# E-183 115 kV Transmission Line Underground Relocation Project

## Evaluation of National Grid's 2014 Underground Estimate

*April 10, 2015*

Figure 1. National Grid's Proposed Alignment for the Underground Portion of E-183

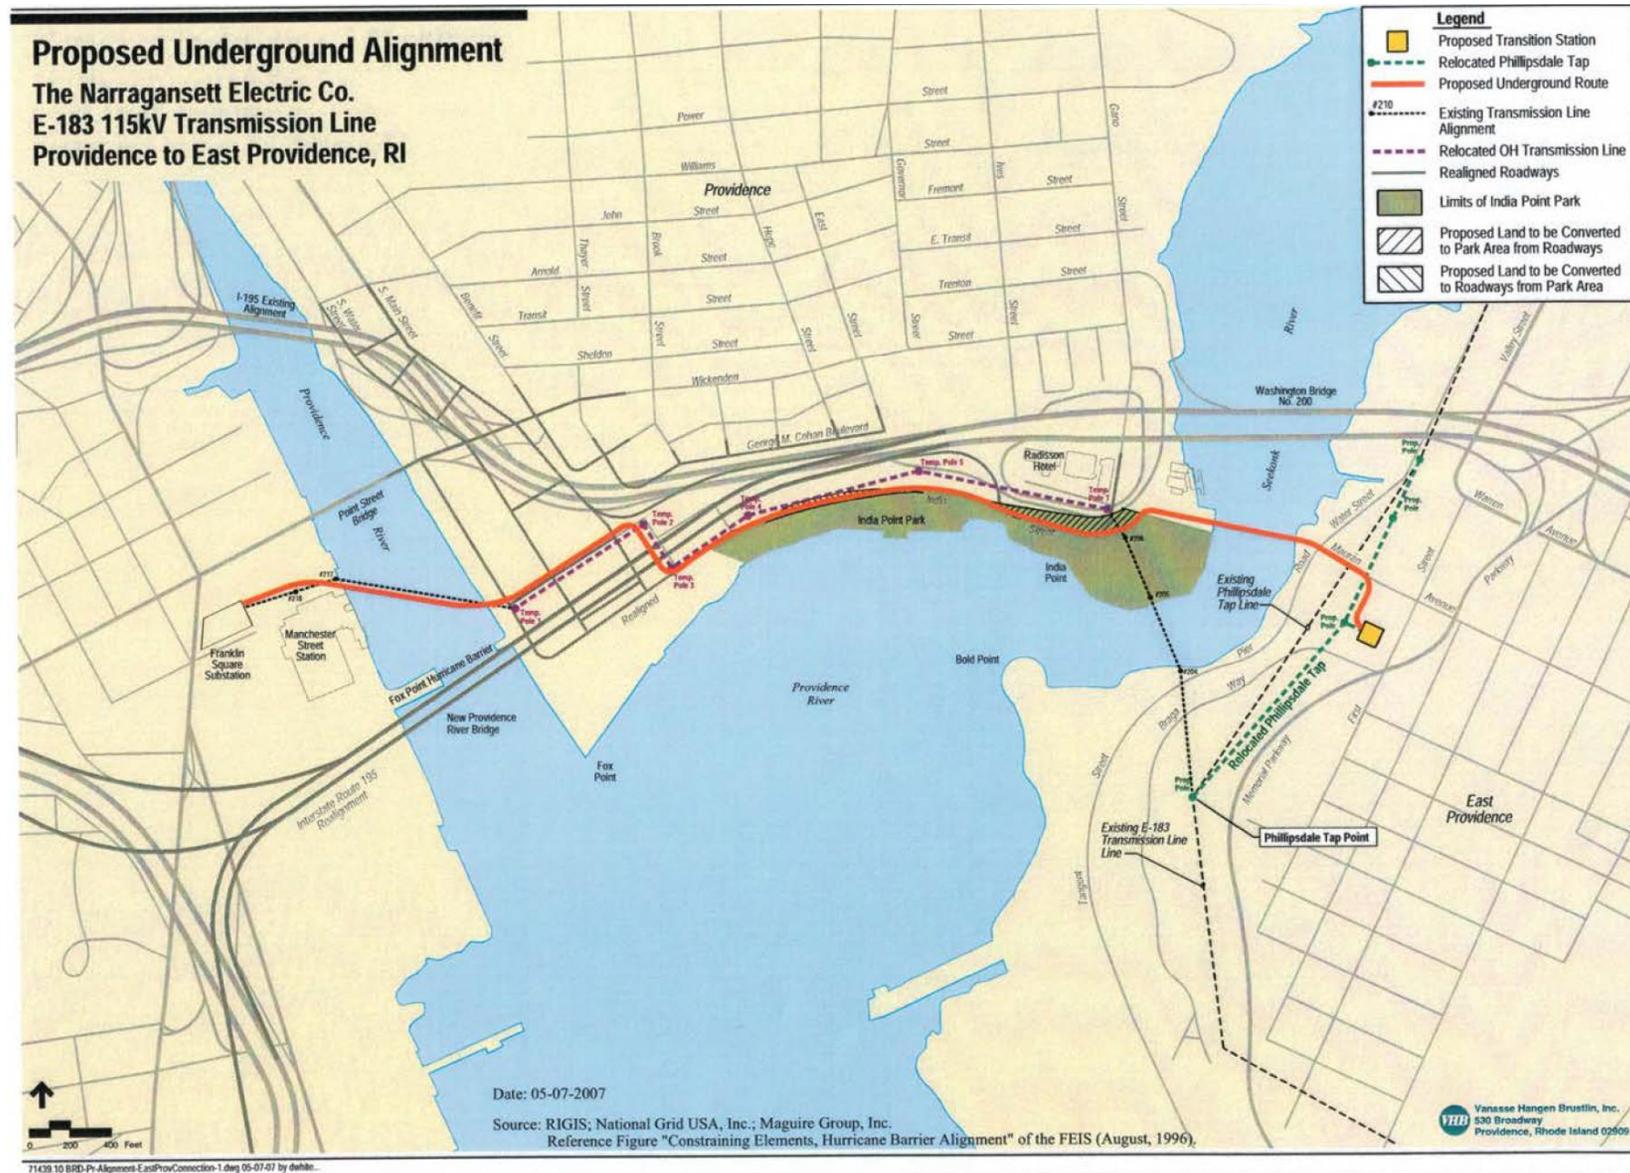
According to The Narragansett Electric Company E183W – Underground Project Investigation & Estimate Assumptions dated Oct. 29, this route is approximately 6,330 ft long, includes two horizontal directional drills, one jack-and-bore, with the remainder being installed by open trench excavation. The directional drills are each proposed to include two parallel bores with one cable per phase (i.e., three cables) in each bore. The jack-and-bore is proposed to include two cables per phase in the one bore.

According to the Plan drawings P2-1 through P2-8 dated 8/13/14, Power Engineers is planning on 5 vault locations with 1 vault per phase for a total of 10 vaults.

For the HDD crossing of the Providence River, Power Engineers states that the depth of vertical alignment will be 35 to 60 feet, but data from the new I-195 bridge downstream of the hurricane barrier indicates 29 feet of fill over 30 to 45 feet of organic silt and silty fine sand that would be considered very soft. That data also indicates that there is significant weight of rod material which is detrimental. Based on the S.W. Cole geotechnical data presented, a prudent engineer would install a conductor sleeve (also known as a casing pipe) to an elevation approximately 60 feet bgs to mitigate potential steering issues, borehole stability issues, and the potential inadvertent returns (i.e., frac-out). A vertical curve cannot begin until after this depth since it will be confined by the straight section of conductor sleeve. The total depth of the 60 feet plus additional depth accumulated going through a vertical curve would be between

105 and 165 feet bgs depending on the entry angle. The geotech borings from S.W. Cole only go to about 80 feet bgs. Power Engineers may not have considered the very loose-to-loose or soft-to-medium stiff ground conditions. Below the depth of 50 feet is well-graded dense sand with gravel. H&A believes the alignment should be below this 50-ft depth to reduce risk.

The drawings from Power Engineers also indicate an HDD entry point at the Manchester Street Station to be only 100 feet from the Providence River. This will place a vertical depth at between 15 and 25 feet below ground surface at the top of the bulkhead when crossing the bulkhead assuming an 8- to 14-degree entry angle based on a typical HDD drill rig for this size crossing. This can be problematic given the potential for abandoned piles, the former bridge in the area, and the geology in the river. On the opposite side of the crossing, based on the Power Engineers drawing, the vertical distance to the pipe at the bulkhead will be 28 to 50 feet deep from the ground surface at the top of the bulkhead.
